<b>APPLICATION FOR PERMIT TO DRILL</b>				<b>1. WELL NAME and NUMBER</b> Greater Monument Butte 15-22-9-15H		
<b>2. TYPE OF WORK</b> DRILL NEW WELL <input checked="" type="checkbox"/> REENTER P&A WELL <input type="checkbox"/> DEEPEN WELL <input type="checkbox"/>				<b>3. FIELD OR WILDCAT</b> MONUMENT BUTTE		
<b>4. TYPE OF WELL</b> Oil Well      Coalbed Methane Well: NO				<b>5. UNIT or COMMUNITIZATION AGREEMENT NAME</b> GMBU (GRRV)		
<b>6. NAME OF OPERATOR</b> NEWFIELD PRODUCTION COMPANY				<b>7. OPERATOR PHONE</b> 435 646-4825		
<b>8. ADDRESS OF OPERATOR</b> Rt 3 Box 3630 , Myton, UT, 84052				<b>9. OPERATOR E-MAIL</b> mcrozier@newfield.com		
<b>10. MINERAL LEASE NUMBER (FEDERAL, INDIAN, OR STATE)</b> UTU-027345		<b>11. MINERAL OWNERSHIP</b> FEDERAL <input checked="" type="checkbox"/> INDIAN <input type="checkbox"/> STATE <input type="checkbox"/> FEE <input type="checkbox"/>		<b>12. SURFACE OWNERSHIP</b> FEDERAL <input checked="" type="checkbox"/> INDIAN <input type="checkbox"/> STATE <input type="checkbox"/> FEE <input type="checkbox"/>

Project: USGS Myton SW (UT)  
Site: SECTION 22 T9S, R15E  
Well: Greater Monument Butte 15-22-9-15H  
Wellbore: Wellbore #1  
Design: Design #1

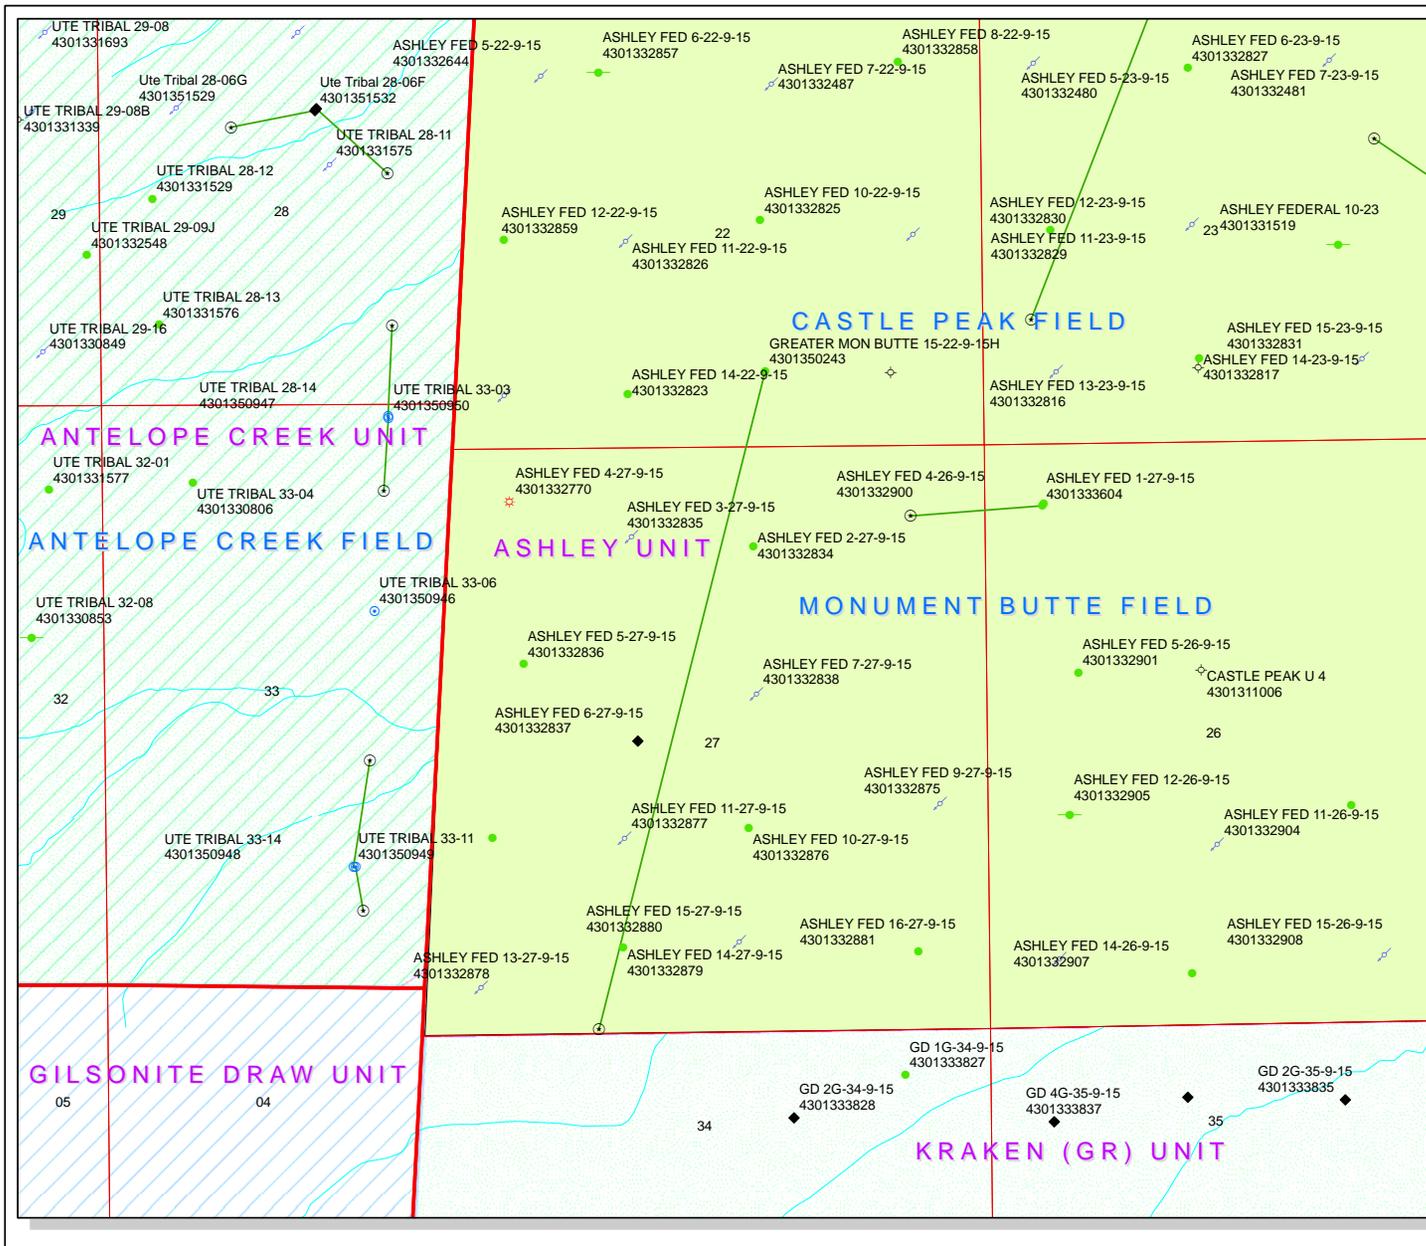
The proposed Bottom Hole location for the above mentioned Horizontal APD has been changed. The new proposed Bottom Hole Footages will be 730' FSL and 1380' FWL. SE/SW Sec. 27, T9S R15E. Attached find the new plat, cut sheets, drilling program, and directional drill plan reflecting this change. The remainder of the approved APD will remain the same.

# T9S, R15E, S.L.B.&M.

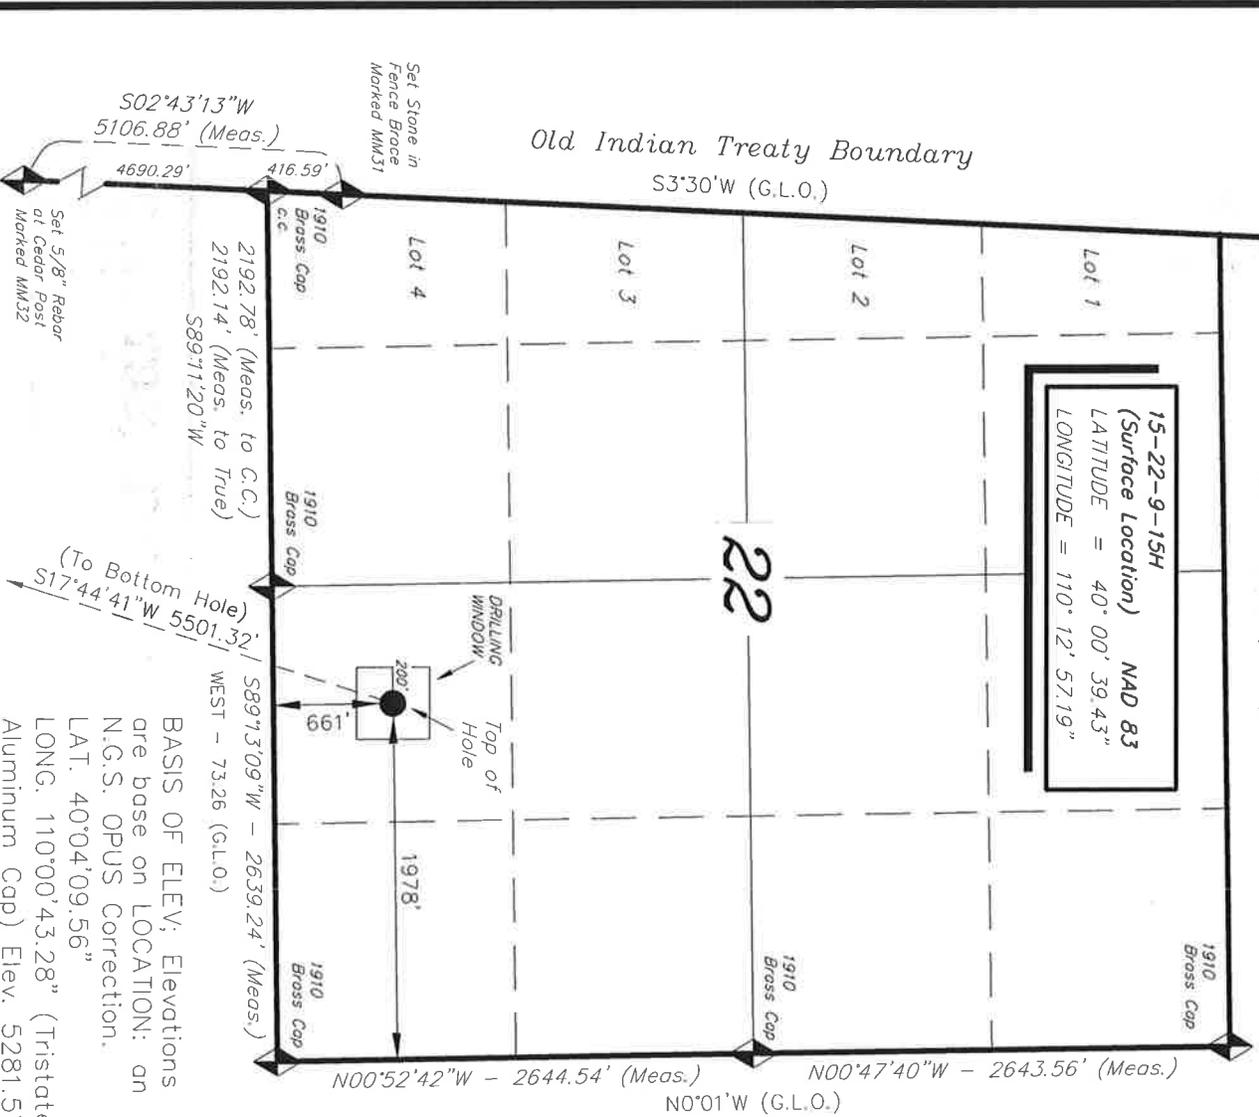
15-22-9-15H (PROPOSED)  
661' FSL & 1978' FEL

15-22-9-15H (PROPOSED)  
730' FSL & 1380' FWL

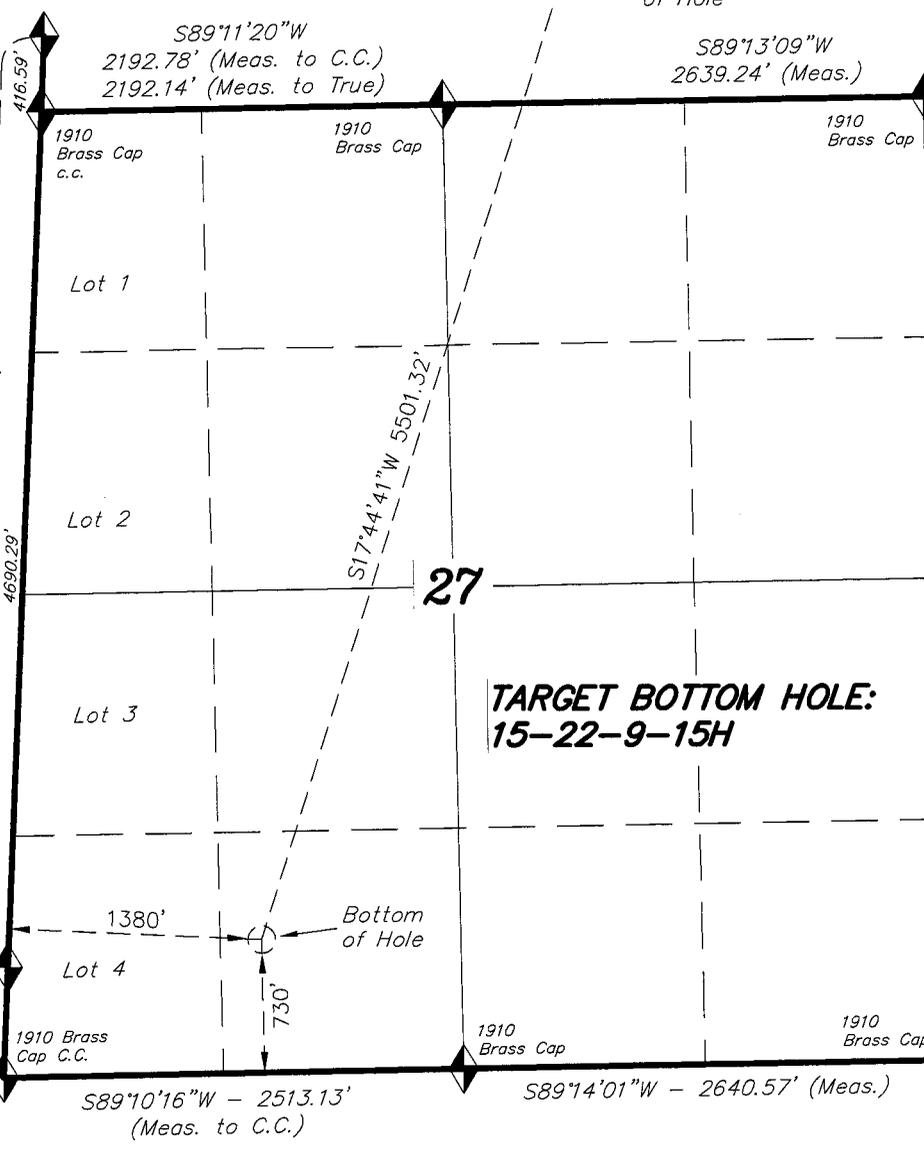
The permit for the above-cited well was for a well bore advanced to the northeast. The plat map I received from Jennifer on June 1 shows the well bore going southwest. Please submit an explanation for this well's bottom hole location and a letter of Exception Location to the Utah Division of Oil, Gas and Mining, to my attention. Thank you.

In reviewing this Well Completion Report, we need to amend what we submitted. We had revised the APD prior to drilling this well. I have attached that Approved APD Revision.
